Section 42A Report to the Hearings Committee

Proposed Plan Variation 2

Hill Country Landscape Domain Boundary Review

November 2014

6.3.6 Amend Planning Maps 38 and 39 in relation to eight lots at the end of Gladstone Road

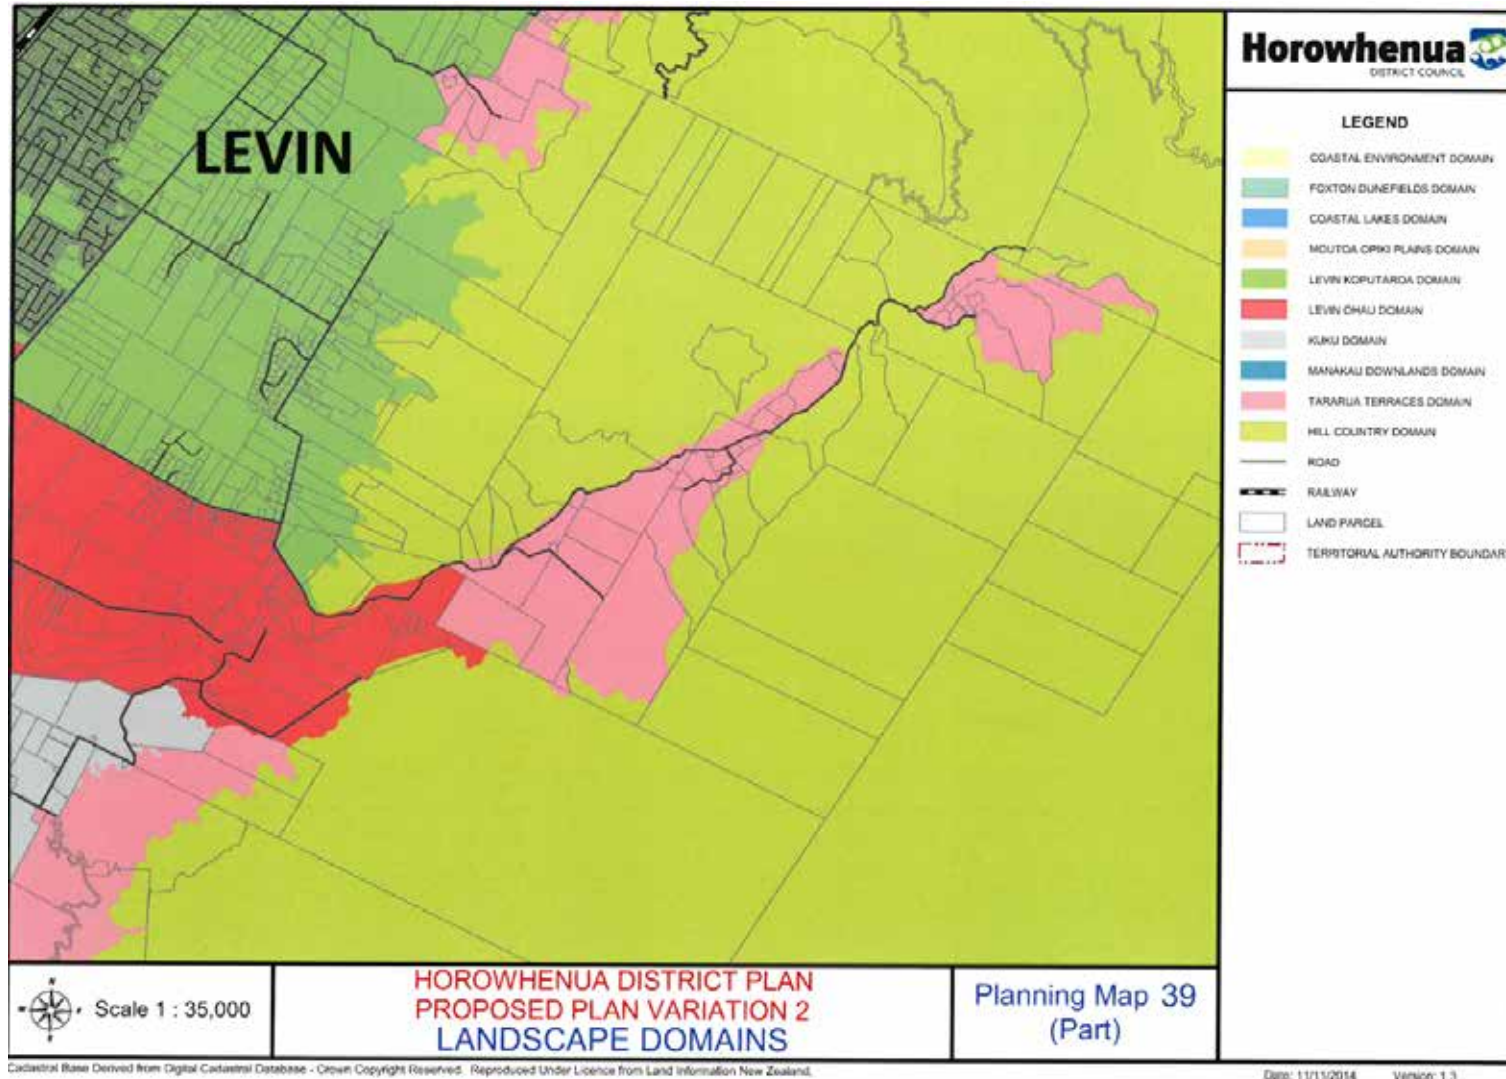
3. Having undertaken a site visit I consider that there is some scope to remove portions of the submitter's properties from the Hill Country Landscape Domain which are relatively flat or are low-lying river terraces. This land is more closely aligned with the Tararua Terraces Landscape Domain characteristics rather than the Hill Country Landscape Domain. The area that has been identified that could potentially be removed from the Hill Country Landscape Domain crosses parts of eight (8) lots that are owned by the submitter. Boyden Evans, Landscape Architect from Boffa Miskell Ltd, accompanied me on the site visit and he is also supportive of sections of Daniel Kilsby-Halliday's properties being removed from the Hill Country Landscape Domain in principal.

5. Removing parts of the submitter's properties from the Hill Country Landscape Domain would provide for a greater level of subdivision to potentially occur than current restrictions would allow. However, the submitter's property already consists of 10 separate Certificates of Titles with each title technically entitled to have at least one dwelling and a family flat built on it as of right under the current provisions of the Proposed District Plan. Therefore while a high level of development is not considered to be desirable due to the remoteness of the properties, it is noted that there is already potential for a substantial level of development to occur on the properties owned by the submitter. The remoteness also works in this case as a mitigating factor should further development occur as the effects of development would not be highly prominent.

6. A small portion of land to the north of the submitter's properties, which is owned by Robin and Heather Gaskin (who own Lot 3 DP 6443) and the Crown (which owns Pt Sec 9 Blk III Waiopēhu SD), was identified by Daniel Kilsby-Halliday as being inconsistent with the Hill Country Landscape Domain as well. However, I have considered it not appropriate to remove any of this land from the Hill Country Landscape Domain.

7. There are a number of reasons for this including the fact that there is no formed access to these two parcels from Gladstone Road which means the future development potential of this land is limited and it is likely to be expensive for any developer. Also neither Robin and Heather Gaskin or the Crown have been involved in the plan variation process (in relation to these two lots) and as such may be unaware that a portion of their land was requested to be removed from the Hill Country Landscape Domain. While I acknowledge that the proposed change from Hill Country Landscape Domain to an alternative Landscape Domain would make it less restrictive for these landowners, support from them for this change in landscape domain has not been provided at this time. Mr Kilsby-Halliday may wish to comment on this at the hearing. Furthermore only a small portion of land from either of these properties could potentially be considered to be suitable to be removed from the Hill Country Landscape Domain and as such this would have very little effect on either landowner's ability to develop these properties given that the majority of the land would remain in the Hill Country Landscape Domain. Therefore it is recommended that submission point 211.01) be accepted in-part.

Amend Planning Maps 38 and 39 so that the flat land owned by the submitter at the end of Gladstone Road be removed from the Hill Country Landscape Domain and becomes part of the Tararua Terraces Landscape Domain as shown in the map in Appendix 3 (Section 6.3.6).
